Village of Arlington Heights
Plan Commission
Board Room
Arlington Heights Village Hall
33 S. Arlington Heights Road
Arlington Heights, IL 60005
August 24, 2016
7:30 PM

- A. Arlington Ale House - 111 W. Campbell St.-3rd Floor - PC#16-019
Special Use for Restaurant, Land Use Variation
- B. Kensington School - 840 E. Kensington Rd. - PC#16-007
Special Use for Daycare, Amendment to PUD Ordinance
- C. Potbelly Restaurant - 3400 W. Euclid Ave. - PC#16-018
Special Use for Restaurant & Drive-thru

Case Number: PC 16-007

SHEET TITLE:
SITE PLAN

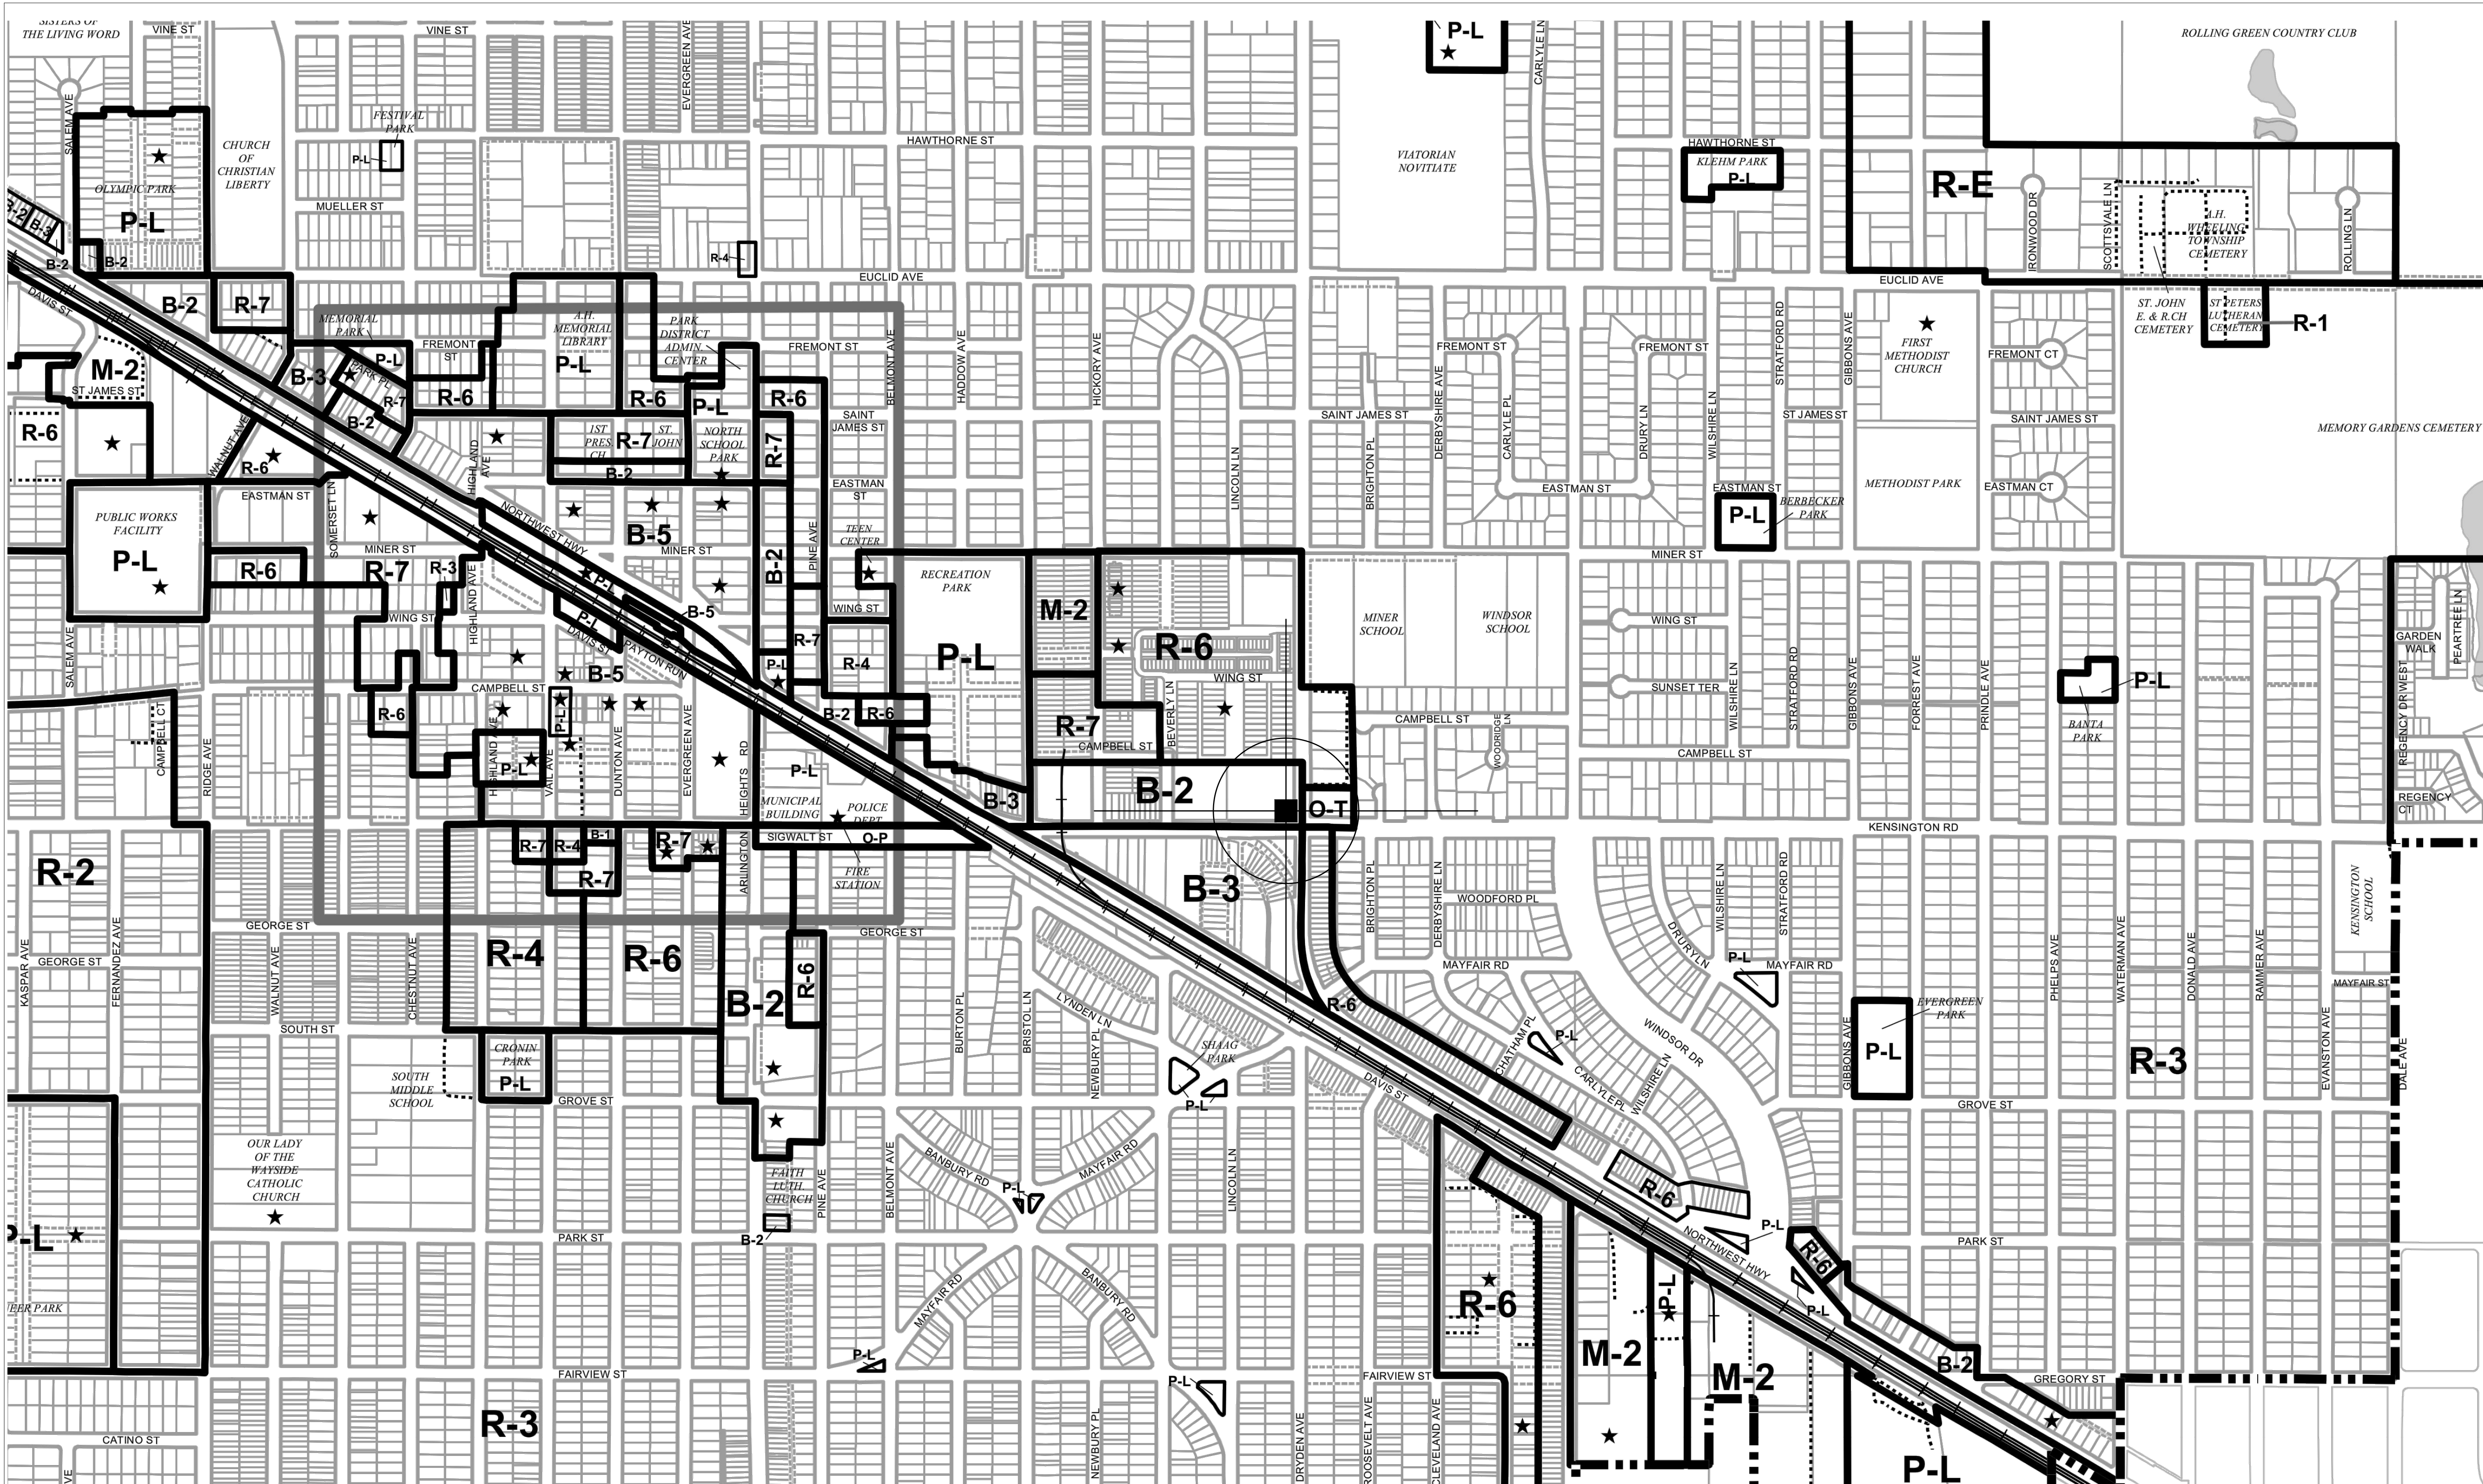
17. Sheet A-07 Site Plan: Consider including bicycle racks in development plan to encourage alternate modes of transportation for employees and patrons.

18. Sheet A-07 Site Plan: Add sidewalk along the west drive lane to provide a continuous north-south walkway from the northern residential sites to the Kensington Road sidewalk. Also extend the sidewalk east from the garbage corral to the Dryden Place sidewalk.

COMMENT 18: Sheet A-07 Site Plan: Add sidewalk along the west drive lane to provide a continuous north-south walkway from northern residential sites to the Kensington Road sidewalk. Also extend the sidewalk east from the garbage corral to the Dryden Place sidewalk.

RESPONSE 18: Sidewalk along the west drive has been revised to connect to the existing sidewalk terminus provided by the townhome development to the north and has been extended southerly to the Kensington Road sidewalk. See revised Geometric Plan sheet L1, page 4 of the revised Site Improvement Plans.

FILENAME:
6124GR1.dgn

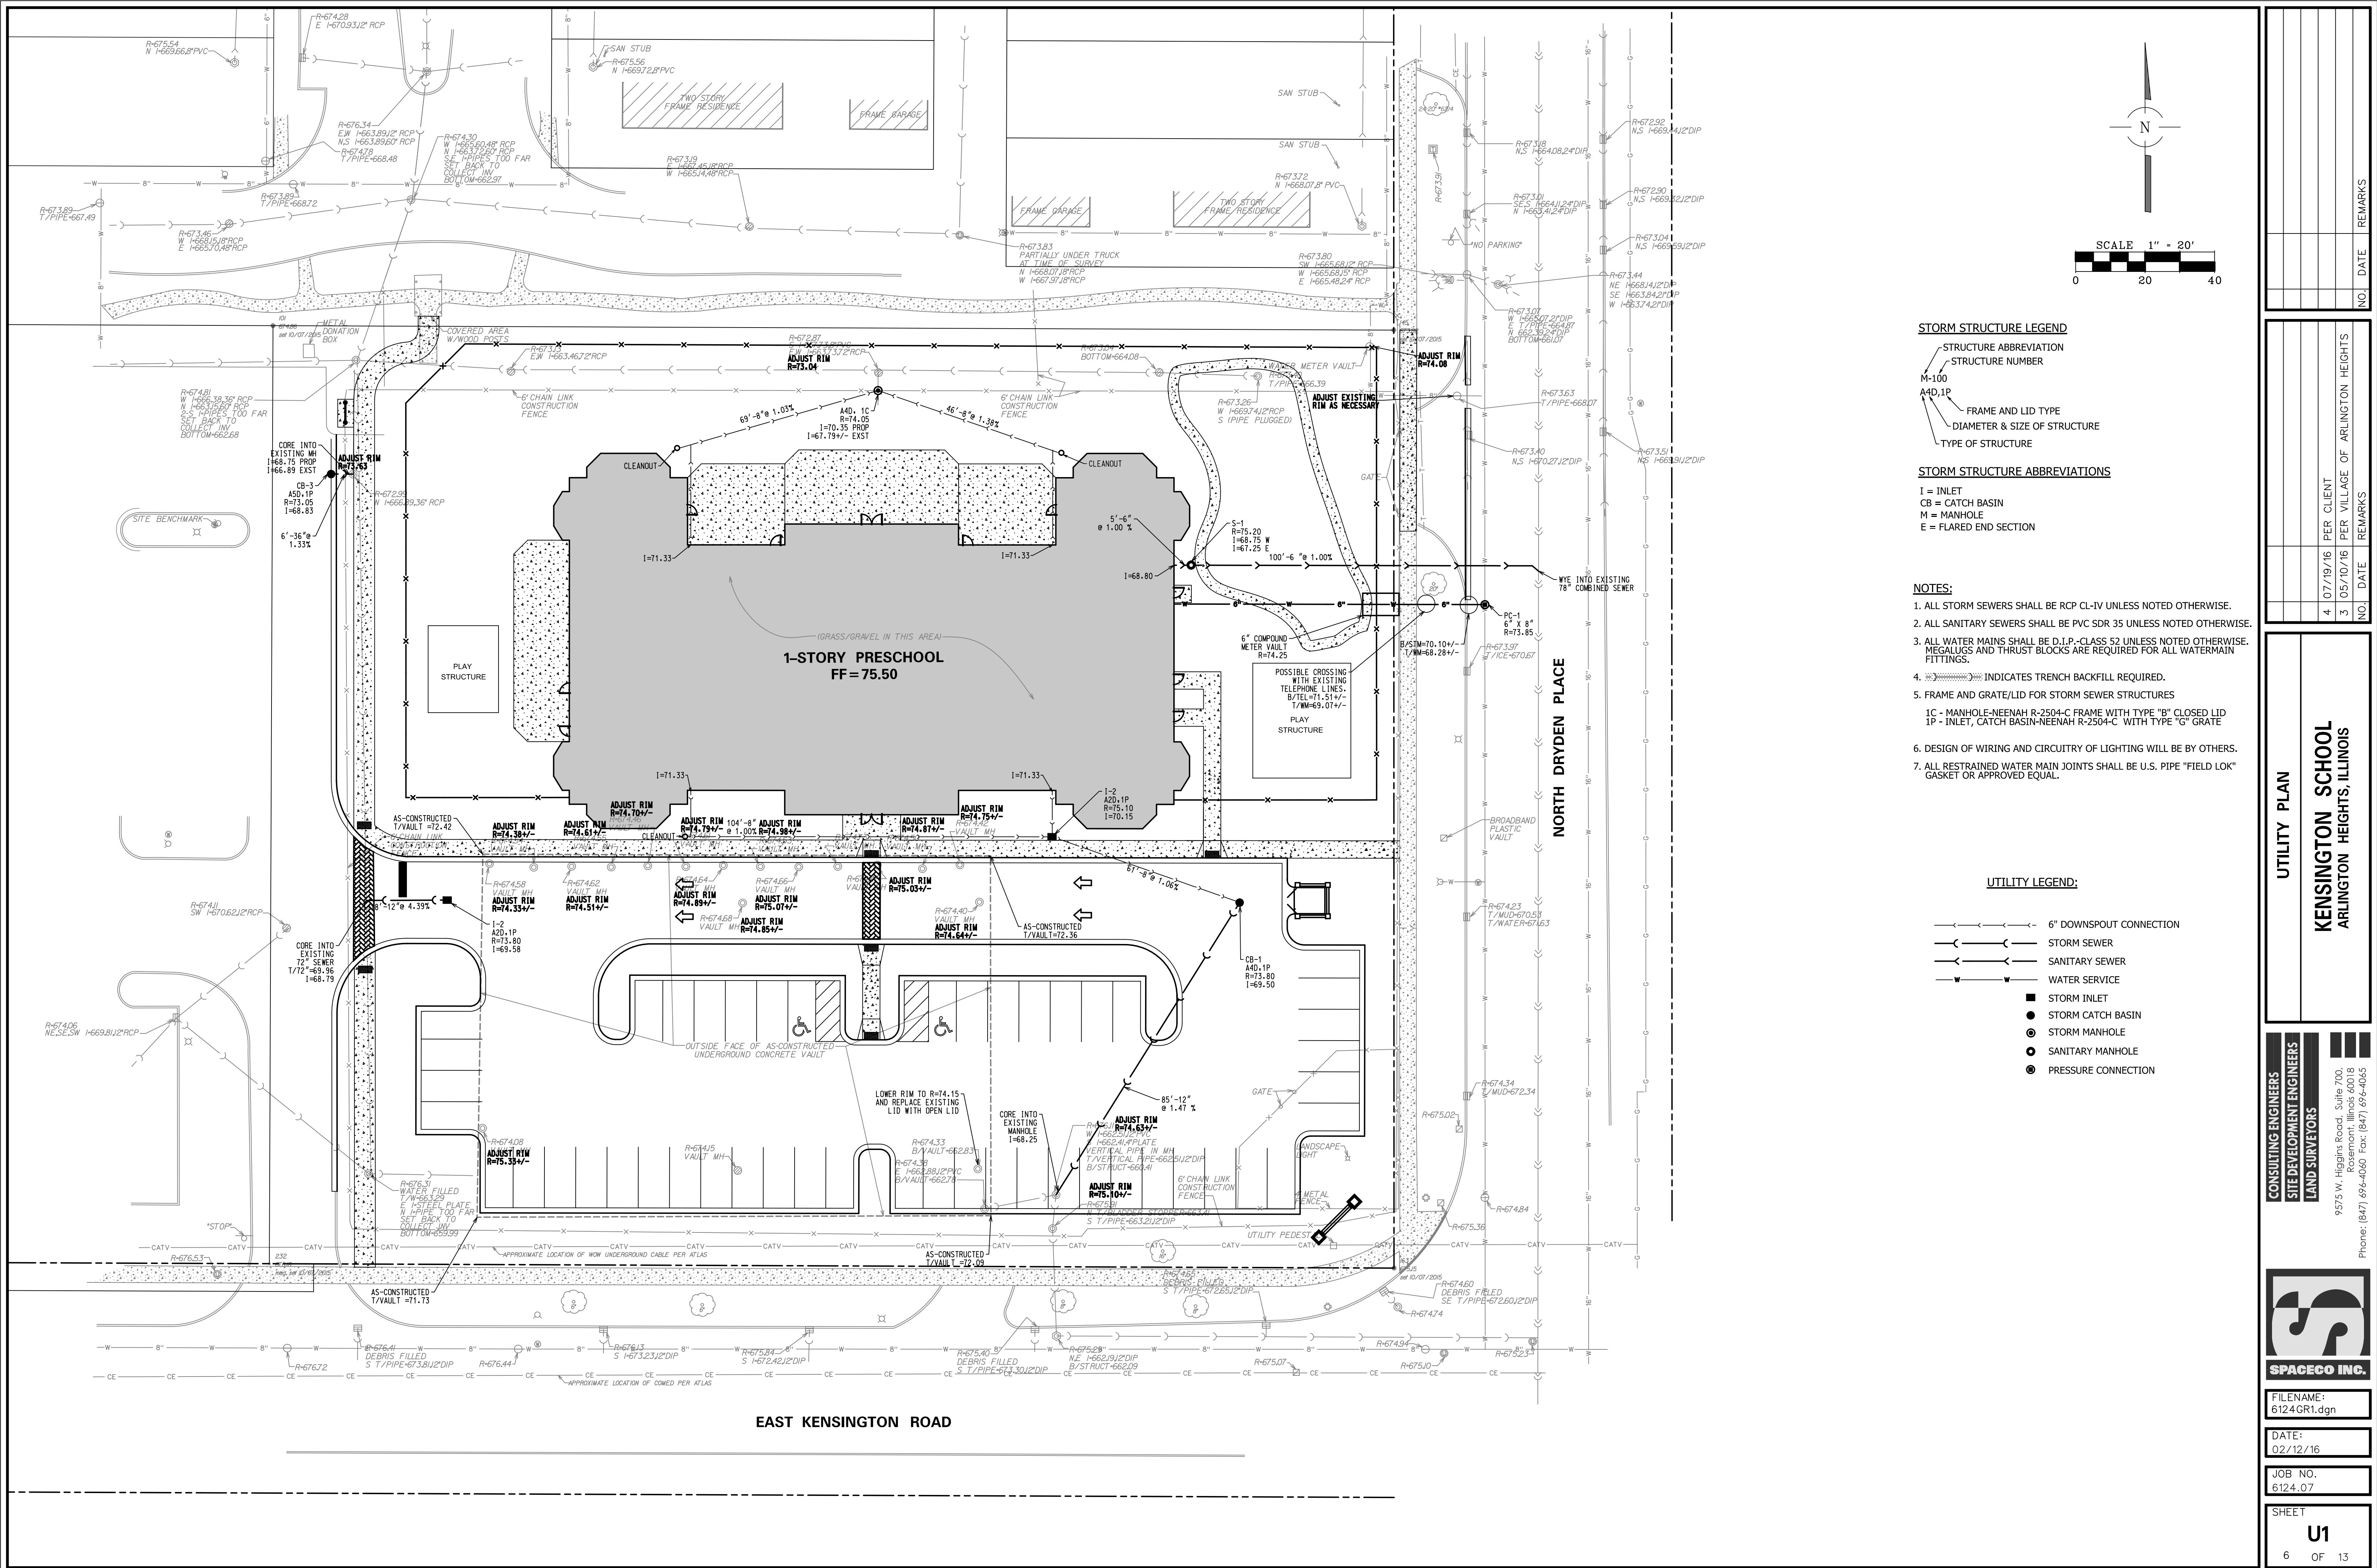
COMMENT 19: Sheet A-08 Grading: The drainage overflow from the residential site to the north is directed south onto the subject property. This overflow must be maintained. It is suggested the subject site be graded to drain to the east toward Dryden Place. Grading should be carefully adjusted when the existing driveway on Dryden Place is removed, replacing and lowering the public sidewalk as necessary to allow overflow to Dryden Place. The design of

RESPONSE 19: The grading has been adjusted to drain as much of the site as possible toward Dryden Place and to better maintain the existing overflow path. Additionally, notes were added to the grading plan to protect the existing overflow path. See revised Grading Plan sheet G1, page 5 of the revised Site Improvement Plans.
